CLOVERLEAF SUBDIVISION
LOCATED IN NE1/4 OF SECTION 23 AND NW1/4 OF SECTION 24,
TOWNSHIP 11 SOUTH, RANGE 67 WEST OF THE 6TH P.M.,
COUNTY OF EL PASO, STATE OF COLORADO
ROADWAY PLANS

EPC STORMWATER REVIEW COMMENTS
IN ORANGE BOXES WITH BLACK TEXT

CLOVERLEAF FILING 2
EL PASO COUNTY, COLORADO
STORM SEWER AND POND PLANS

PUBLIC UTILTY PLAN

SHEET 6 OF 19

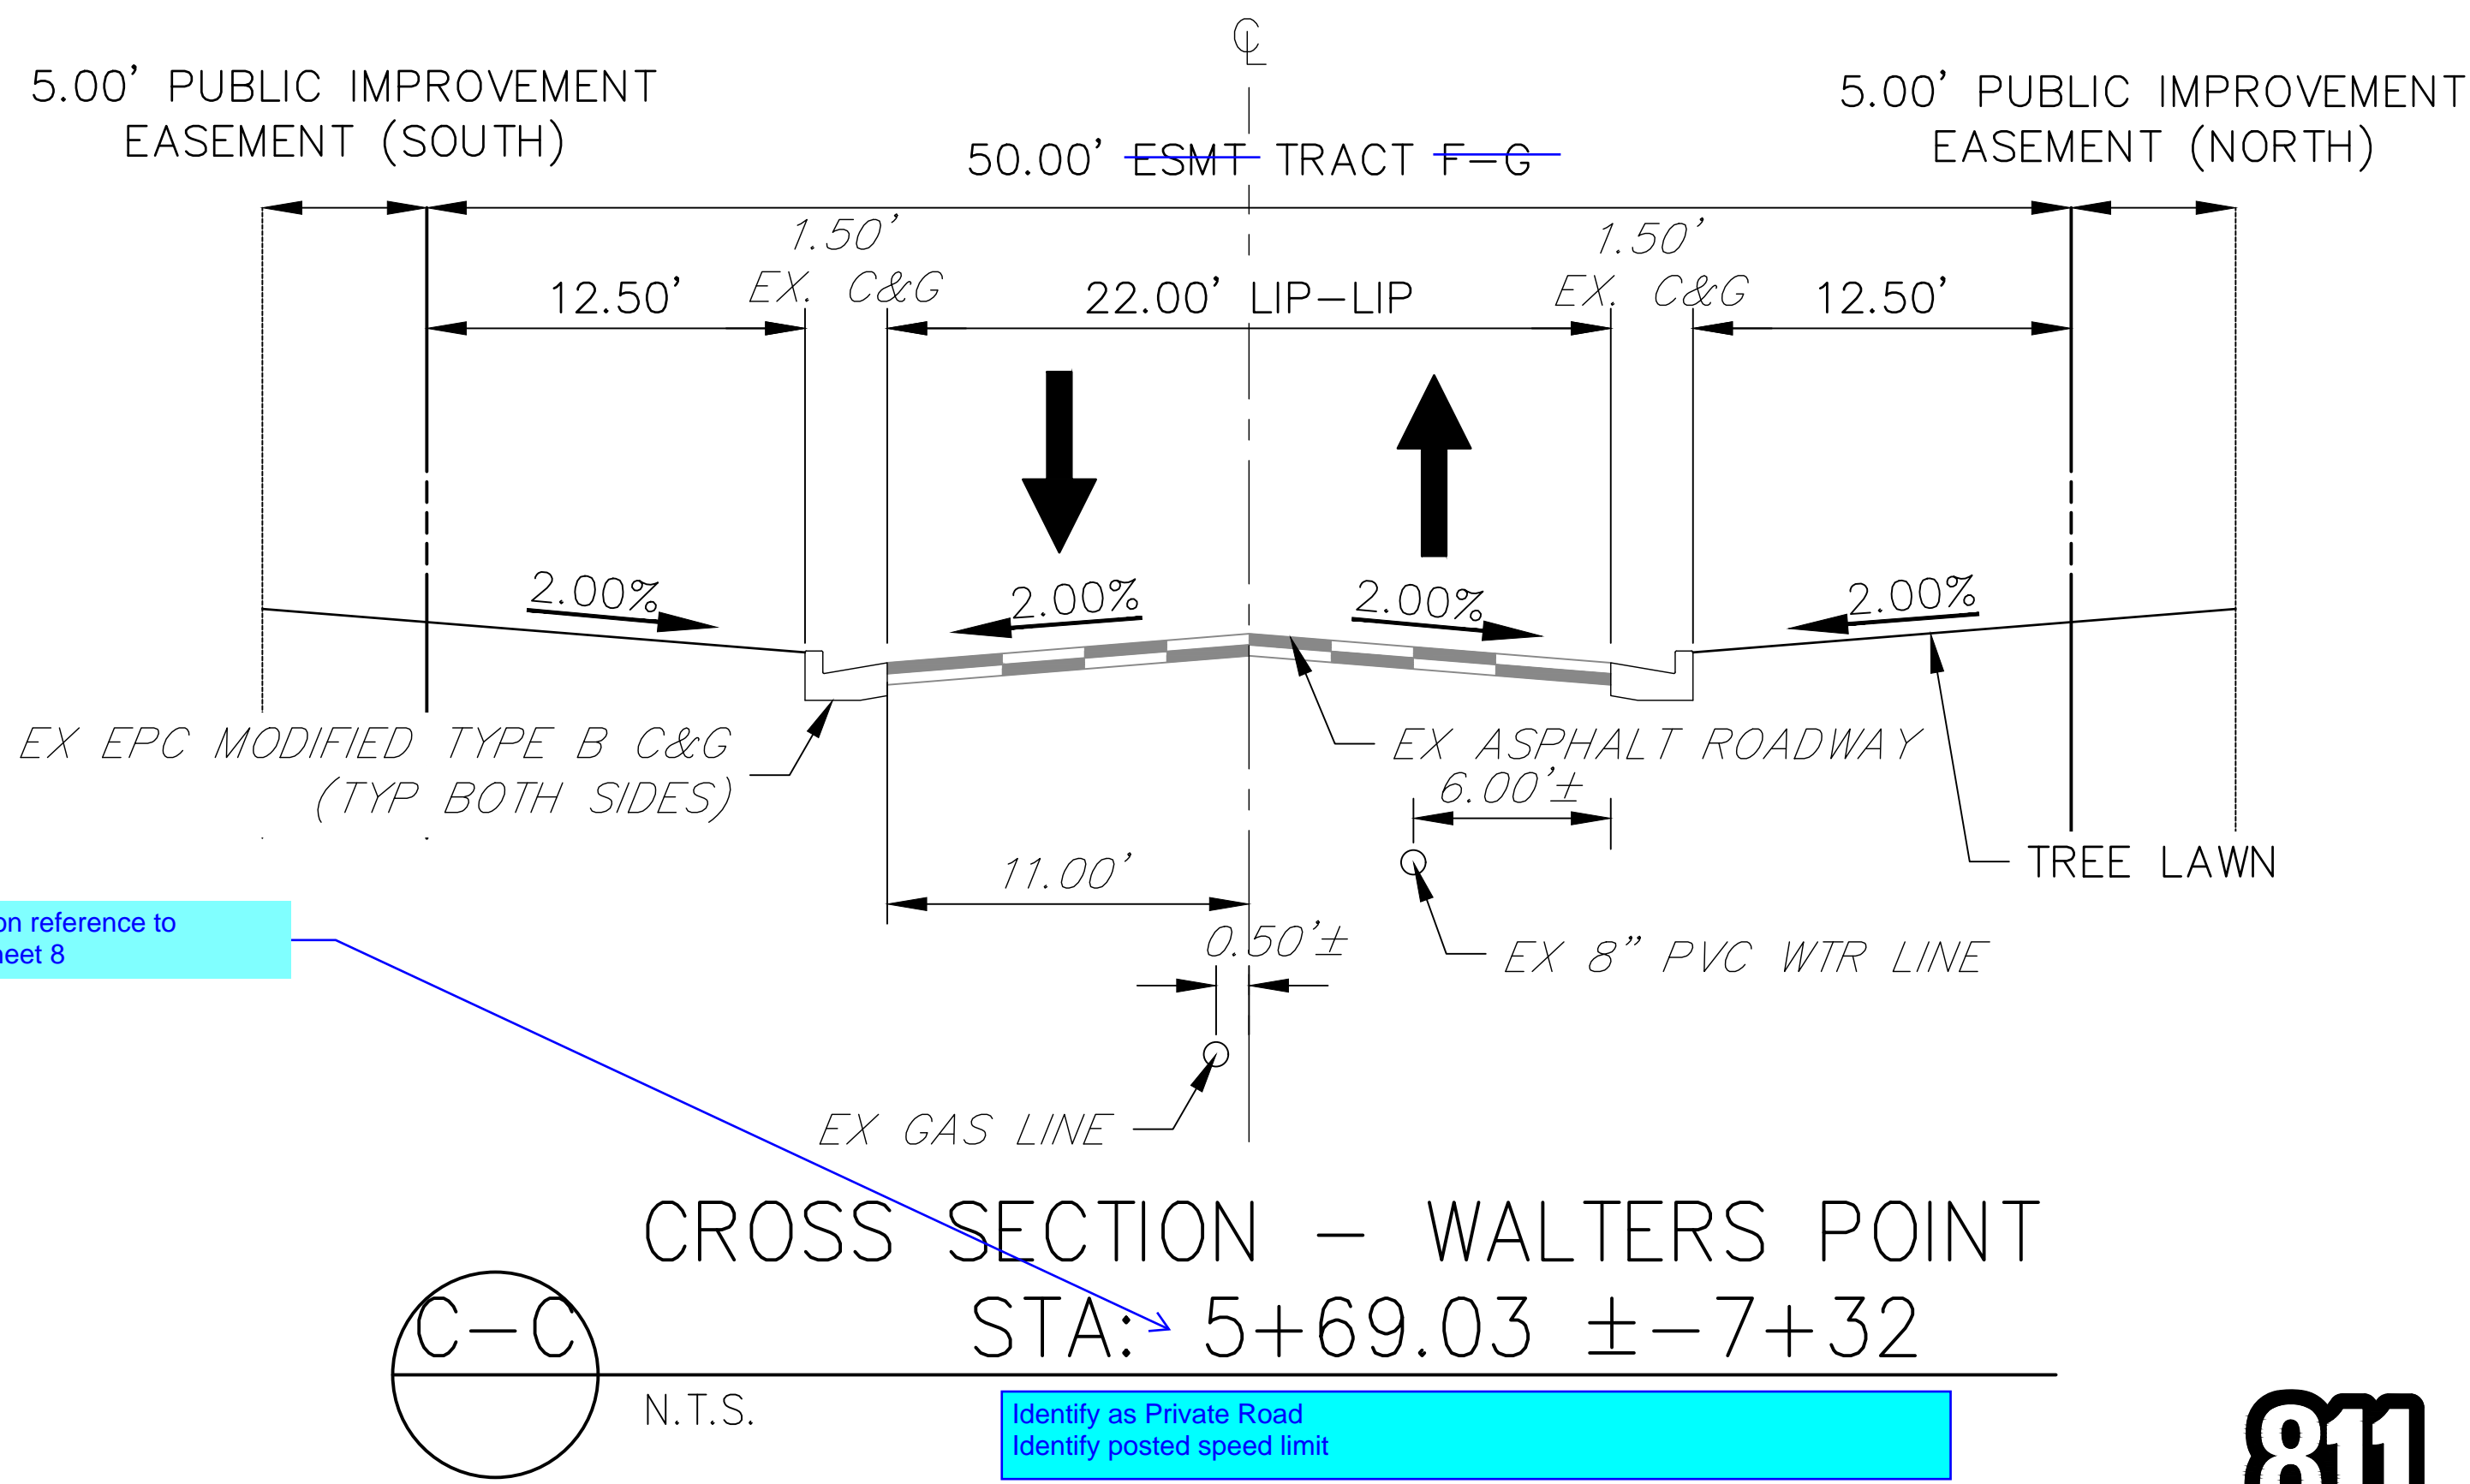
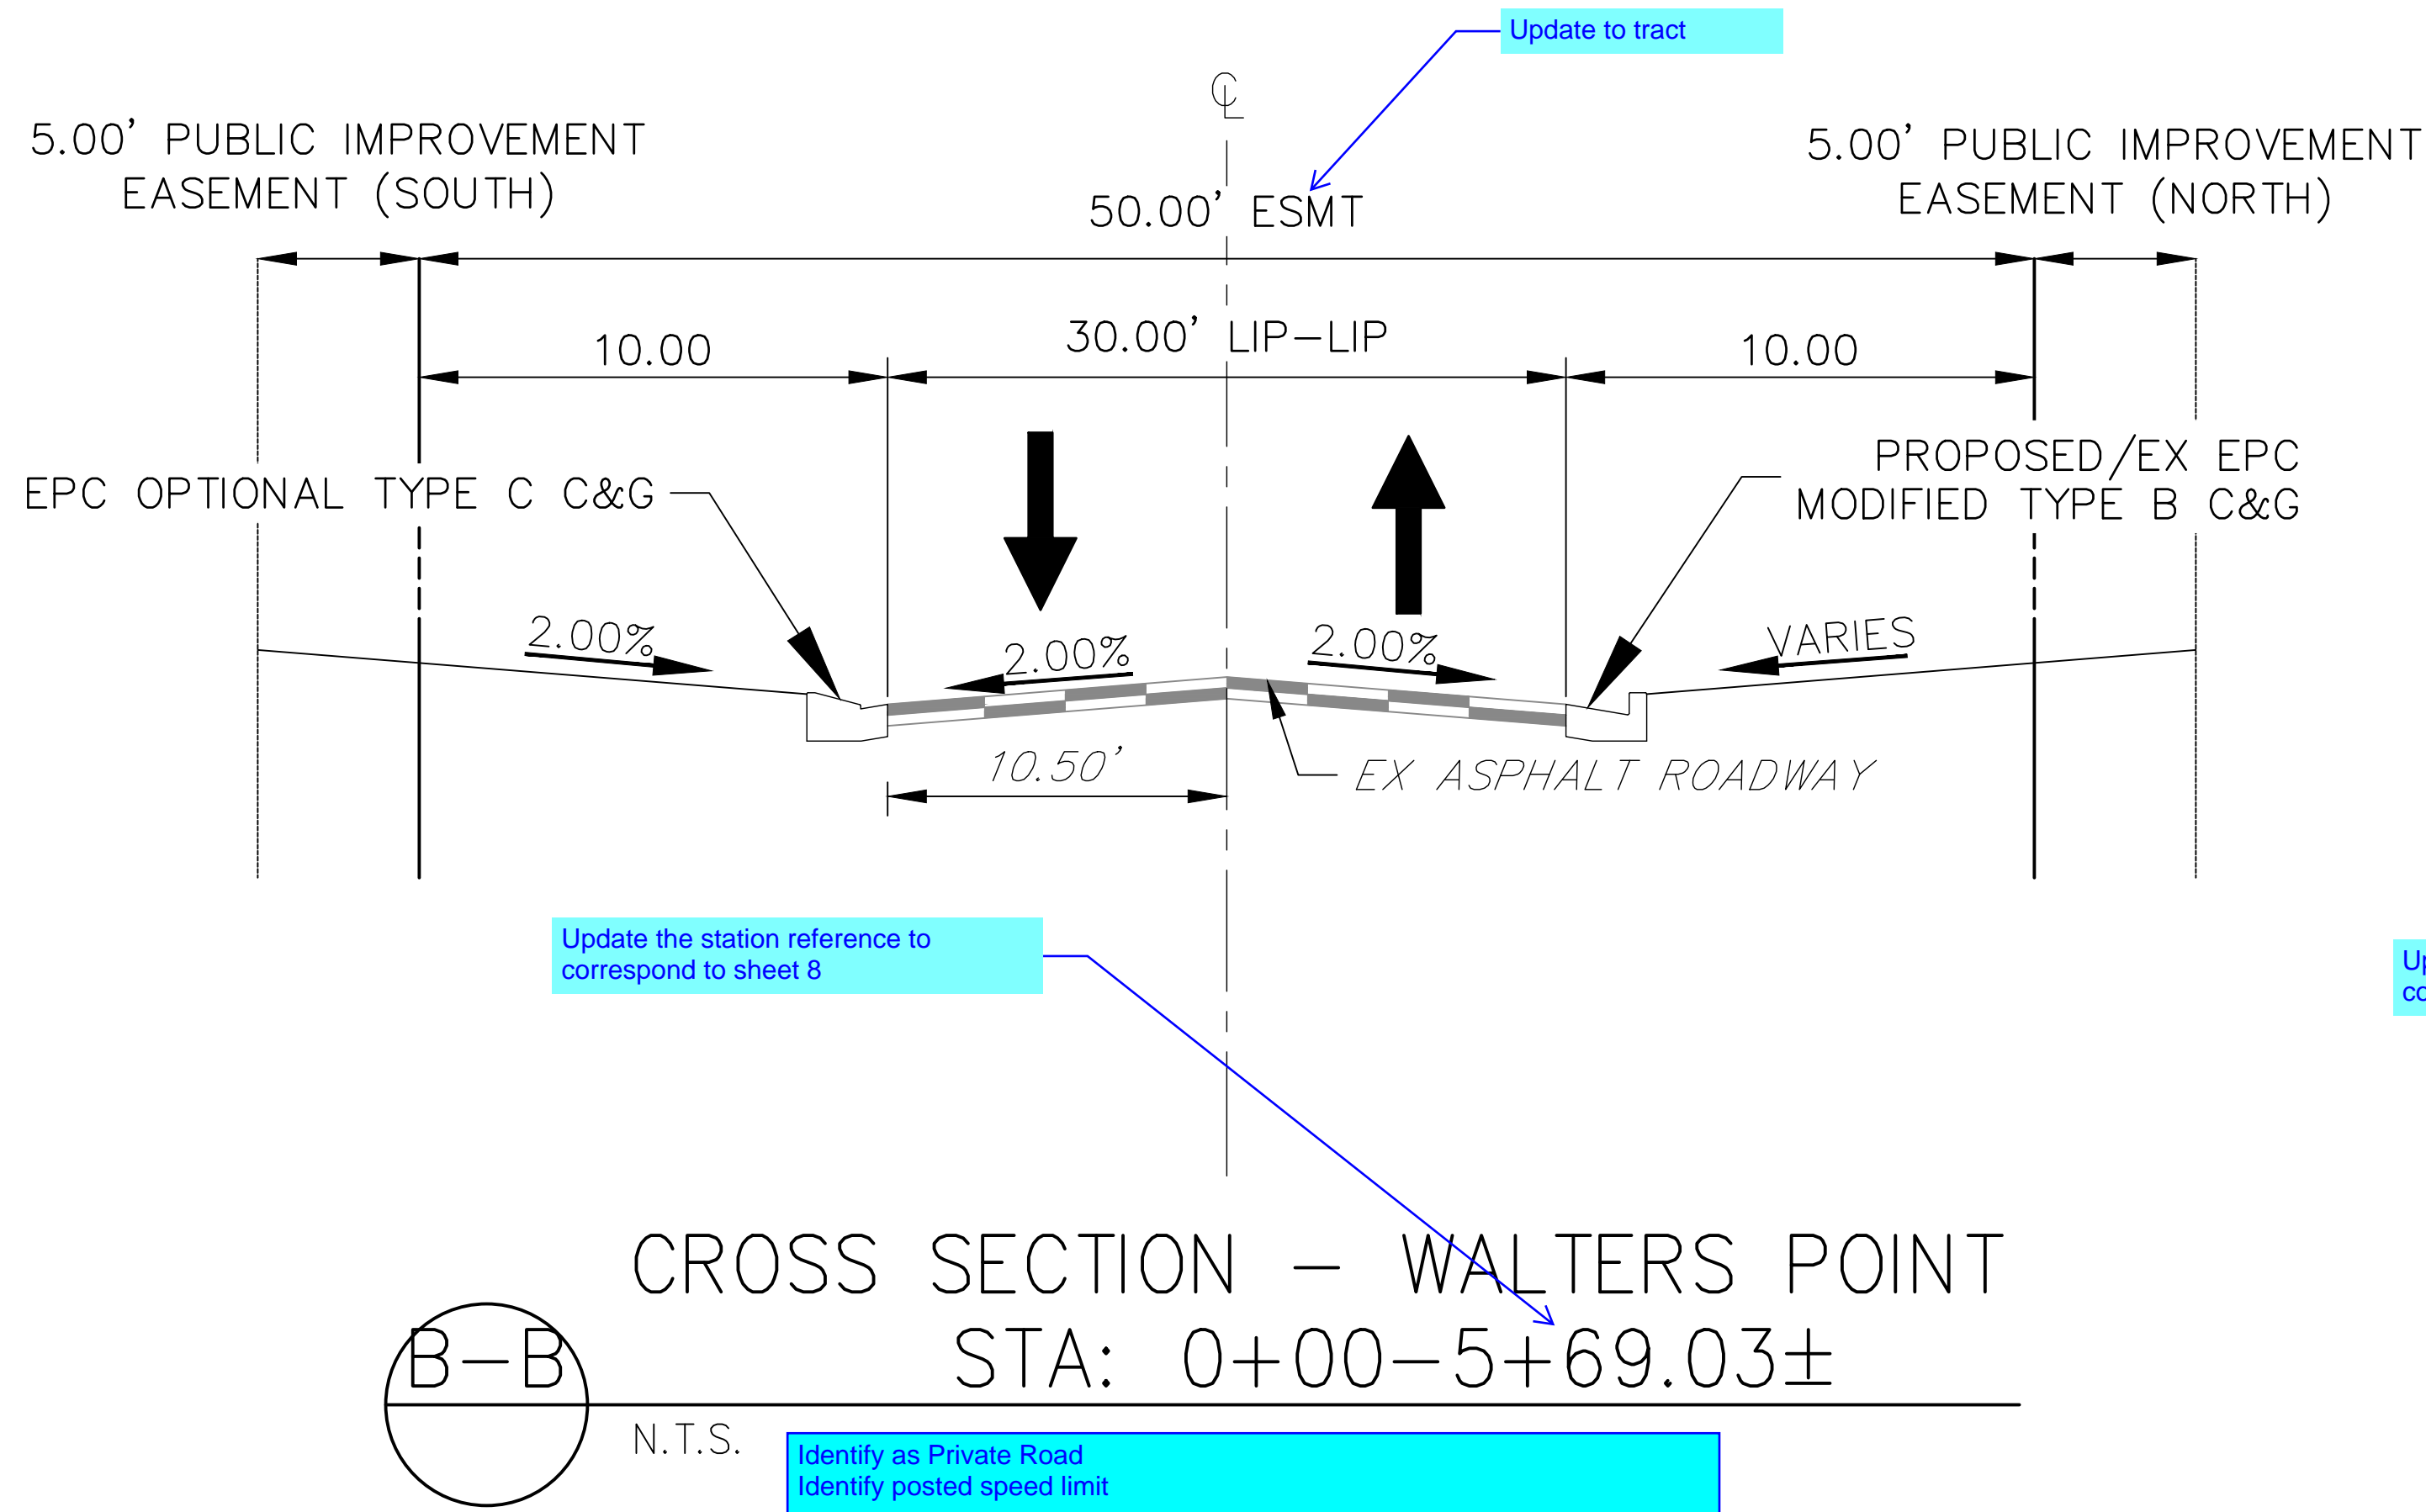
Provide typical cross section of the gravel trail along leggins way

Add road classifications to all cross sections as well as proposed speed limit.

SHEET 8 OF 19

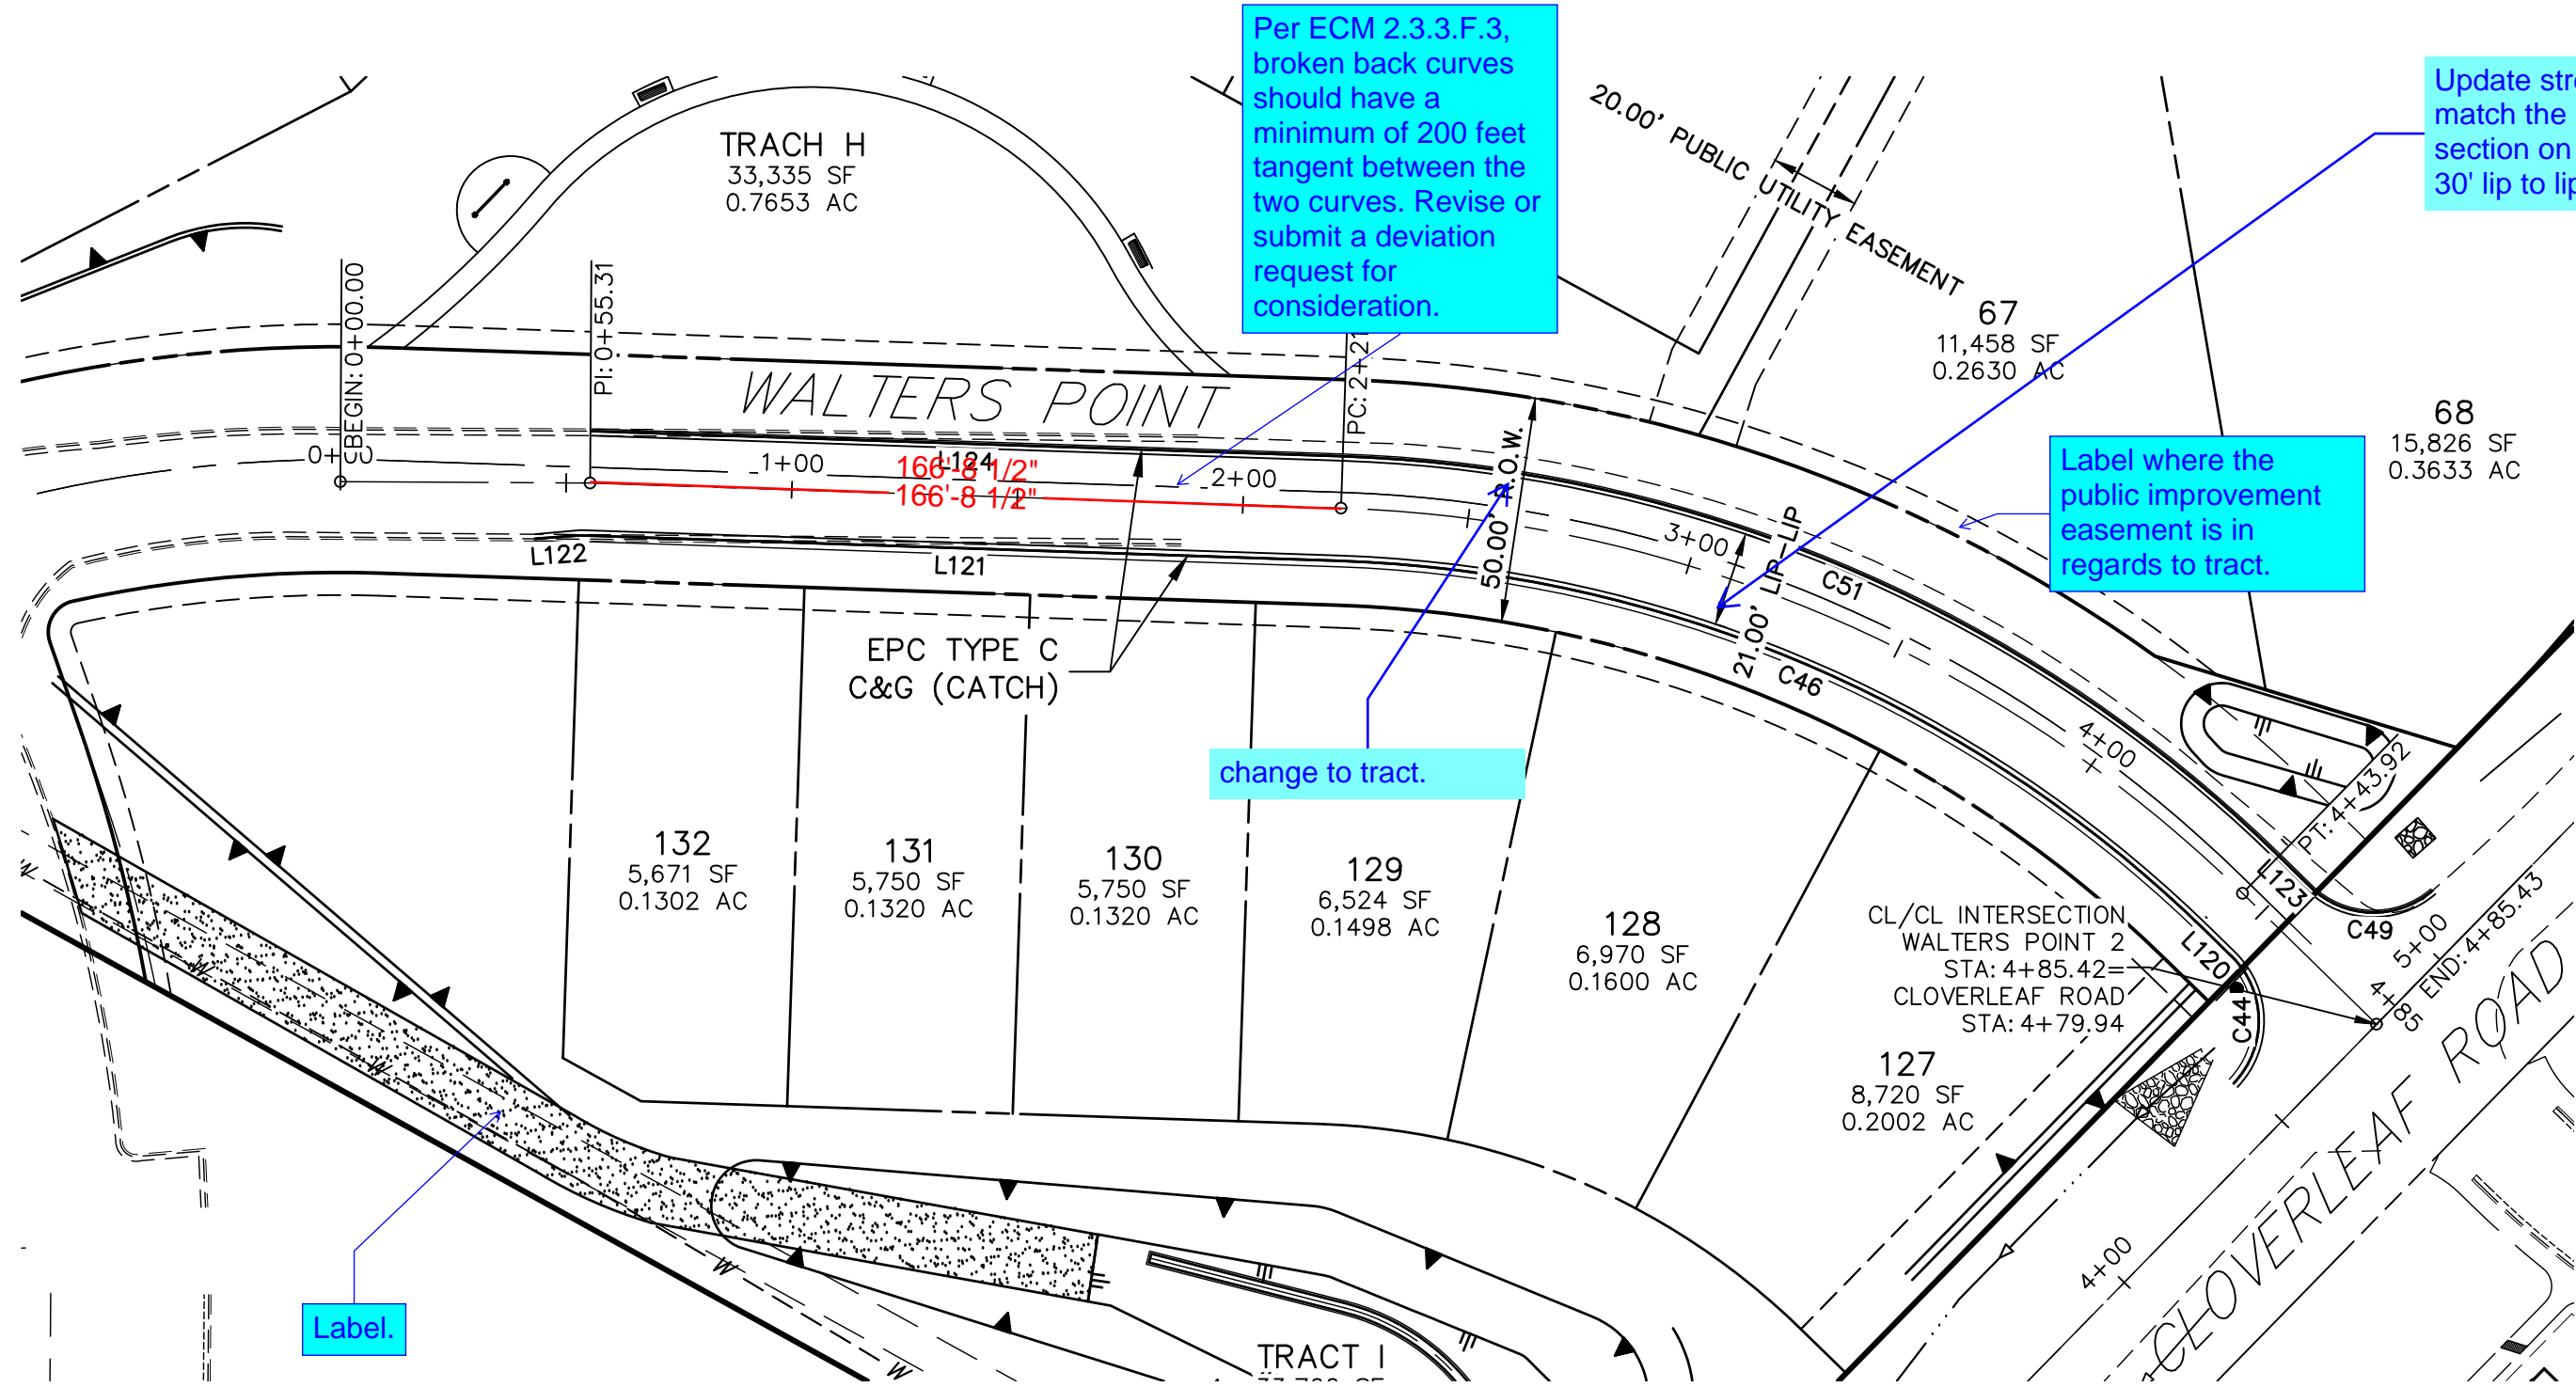
Show tie-in to existing road.
